**ZONING AMENDMENT,
PLANNED UNIT DEVELOPMENT &
SUBDIVISION STAFF REPORT****Date: July 7, 2011**

<u>NAME</u>	Dog River Venture, LLC
<u>SUBDIVISION NAME</u>	Grandview Apartments Subdivision
<u>LOCATION</u>	6151 Marina Drive South (East side of Marina Drive South at the mouth of Dog River).
<u>CITY COUNCIL DISTRICT</u>	District 3
<u>PRESENT ZONING</u>	R-1, Single-Family Residential District
<u>PROPOSED ZONING</u>	R-3, Multiple-Family Residential District
<u>REASON FOR REZONING</u>	Changing conditions.
<u>AREA OF PROPERTY</u>	16.1 Acres ±
<u>CONTEMPLATED USE</u>	<p>Subdivision approval to create 2 legal lots of record from an existing metes and bounds parcel, Planned Unit Development Approval to allow multiple buildings on a single building site with shared access and parking between two building sites, and Rezoning from R-1, Single-Family Residential District, to R-3, Multiple Family Residential District to allow an apartment complex.</p> <p>It should be noted, however, that any use permitted in the proposed district would be allowed at this location if the zoning is changed. Furthermore, the Planning Commission may consider zoning classifications other than that sought by the applic

SITE PLAN

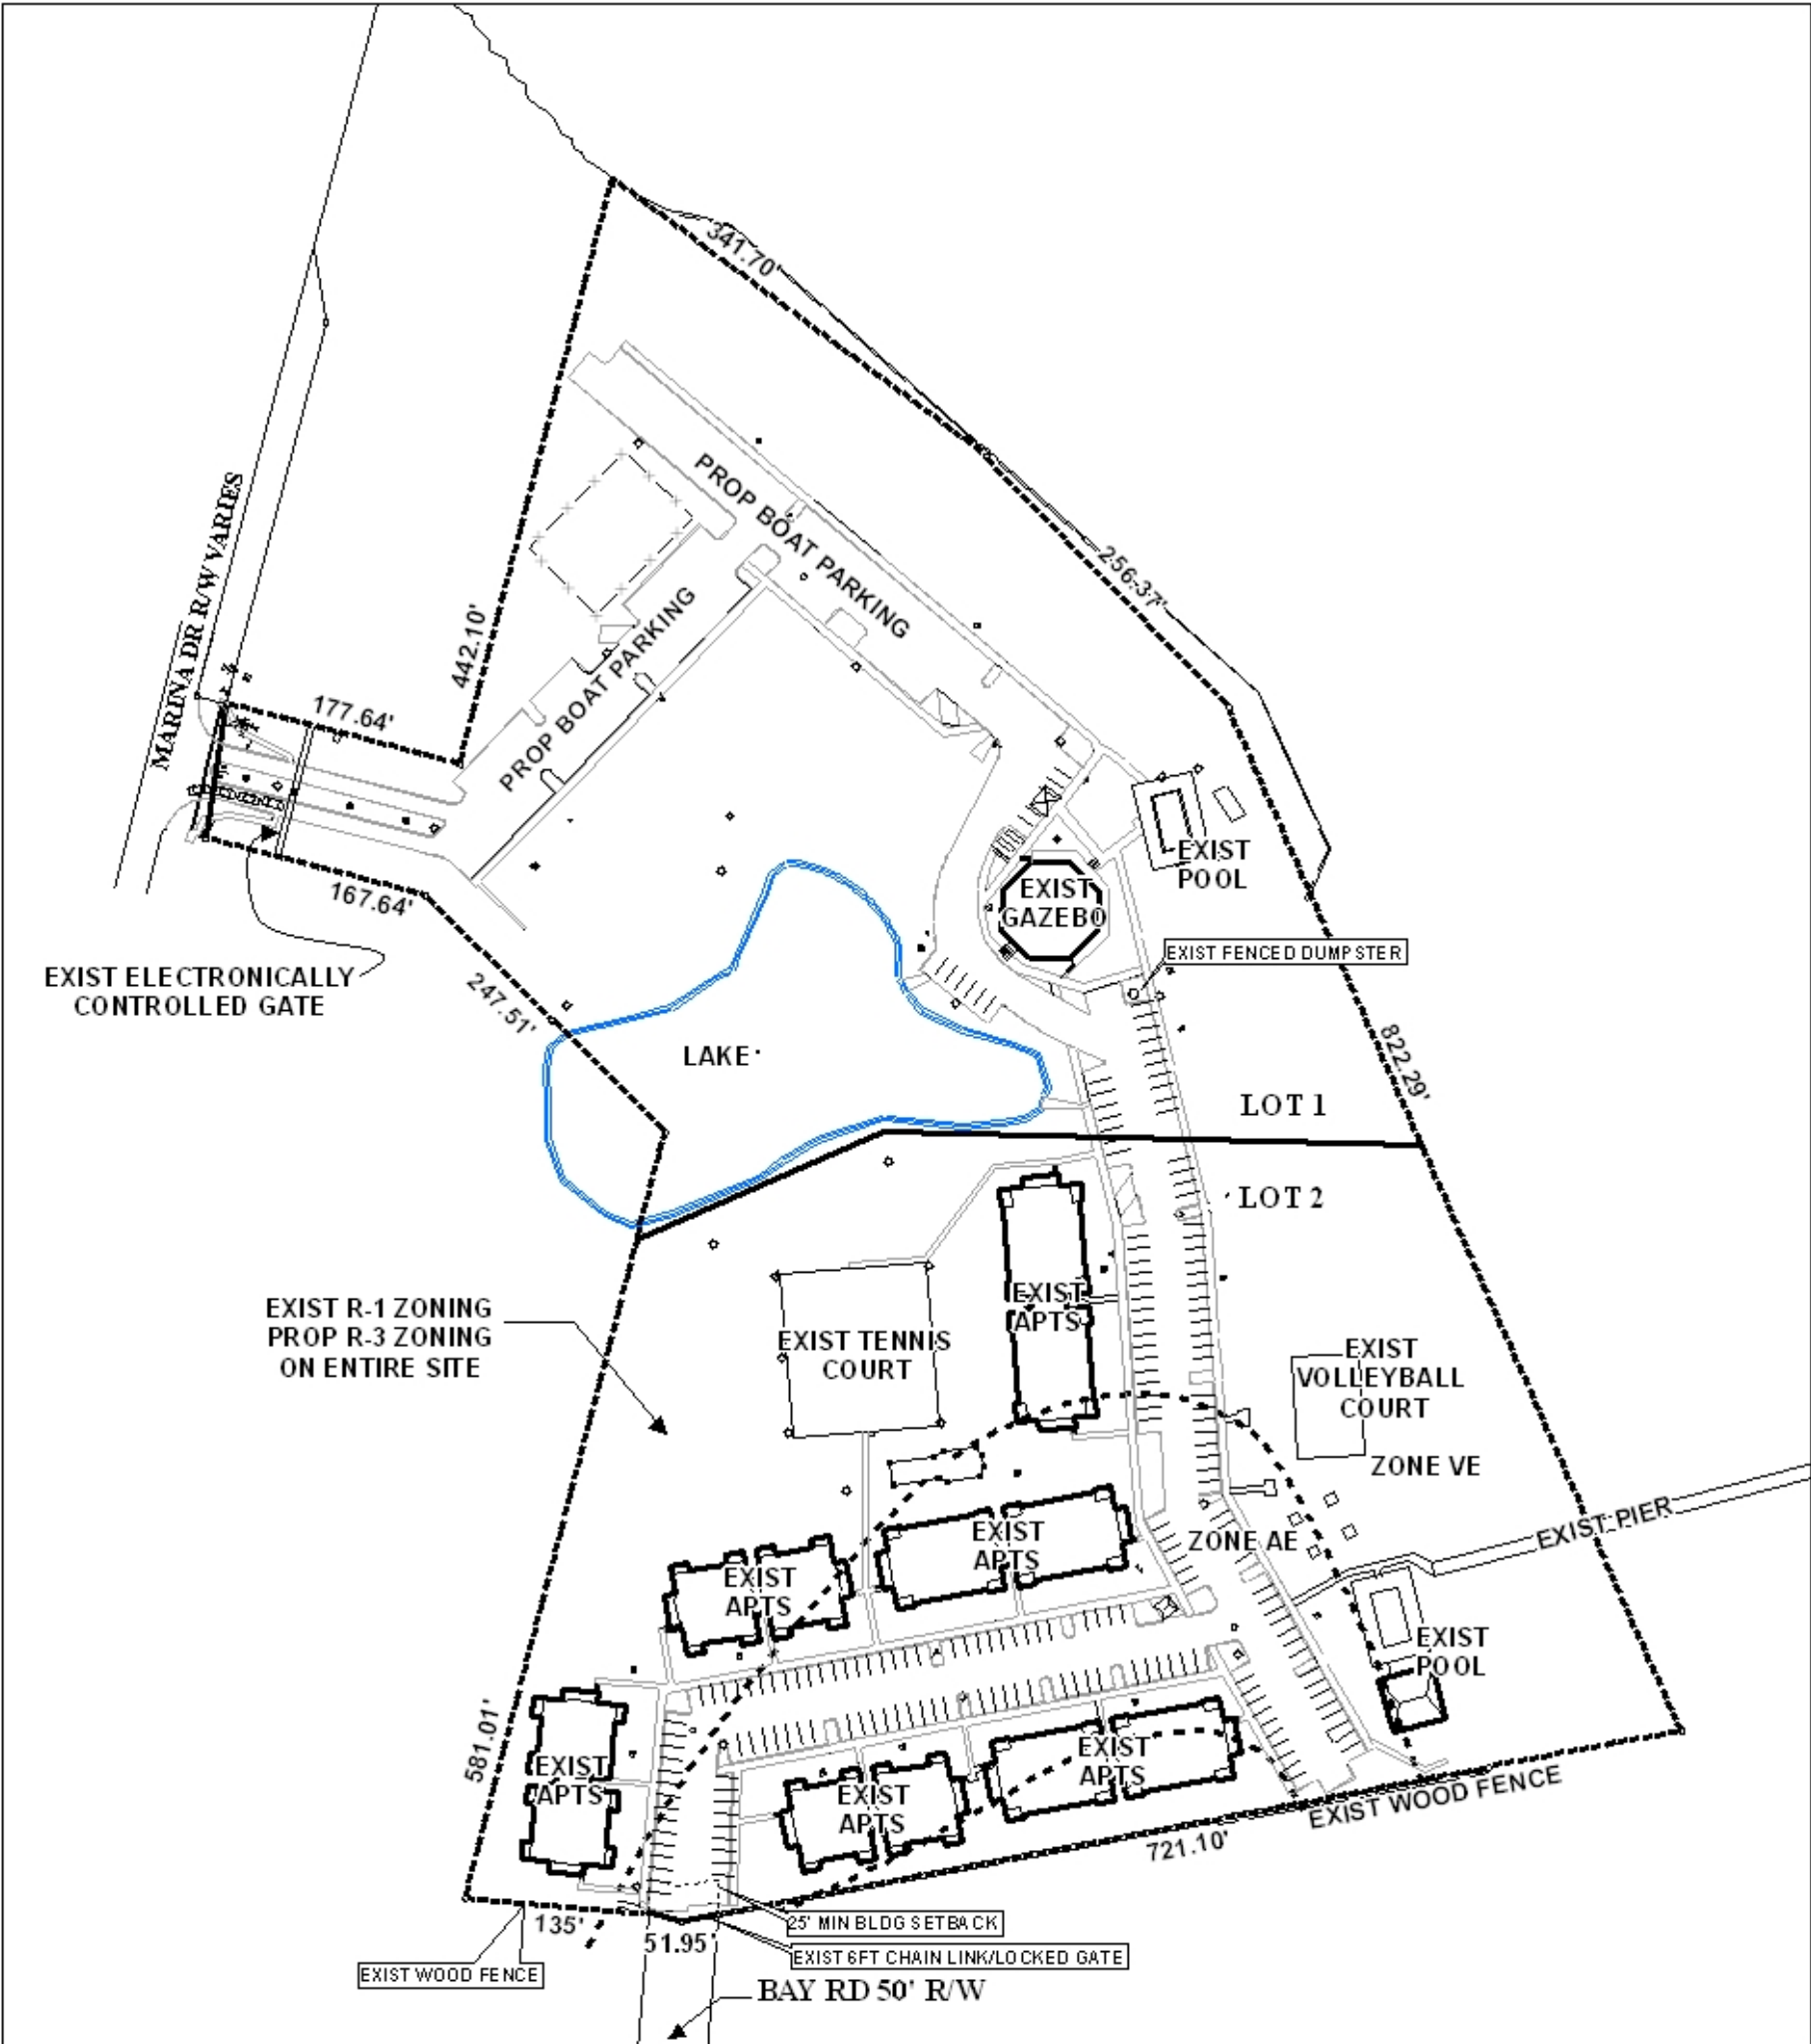
In this case, the site plan submitted by the applicant does not depict all of the improvements on the site, including fences, parking spaces, and dumpster locations. In addition, a gated entrance at Marina Drive South was constructed without permits at some point, and is also not shown on the site plan. The site plan should be revised to depict all improvements, existing and proposed.

The revised site plan depicts the entry gate, as well as adequate queuing area, along Marina Drive South. The site plan does not indicate queuing area at the proposed Bay Road North entrance. As access to Bay Road North is currently denied due to the road quality, this is not as much of a concern as the Marina Drive South entry; however, should Bay Road North be constructed, and an entrance to the apartment complex be constructed from Bay Road, submittal of a new PUD would be required to review the new entrance and queuing spaces. The site plan does indicate cross-access between the two proposed lots. As long as access to Bay Road North is denied, this cross access should remain open. Any closure of this cross access must be approved by a new Planned Unit Development Application. It should also be noted that any redevelopment of either lot will also require a new PUD review.

The site plan did not indicate dumpster locations or curbside pickup. The site plan should be revised to indicate dumpster locations and appropriate enclosures and connections to the

sanitary sewer or a note placed on the site plan indicating that garbage removal will be by curbside pickup.

- 1) completion of the rezoning process;
- 2) revision of the site plan to indicate the location of dumpsters, with appropriate enclosures and connections to the sanitary sewer, or placement of a note on the site plan indicating that garbage removal will be by curbside pickup;

- 3) placement of a note on the site plan that access to Bay Road North is denied until such time as Bay Road North is constructed to county paved road standards as evidenced by a certification from the County Engineer;

- 4) any gated access to Bay Road North, if properly constructed, will require submittal of a PUD to review the access and queuing spaces;
- 5) placement of a note on the site plan stating that development of the site must be undertaken in compliance with all local, state and Federal regulations regarding endangered, threatened or otherwise protected species;
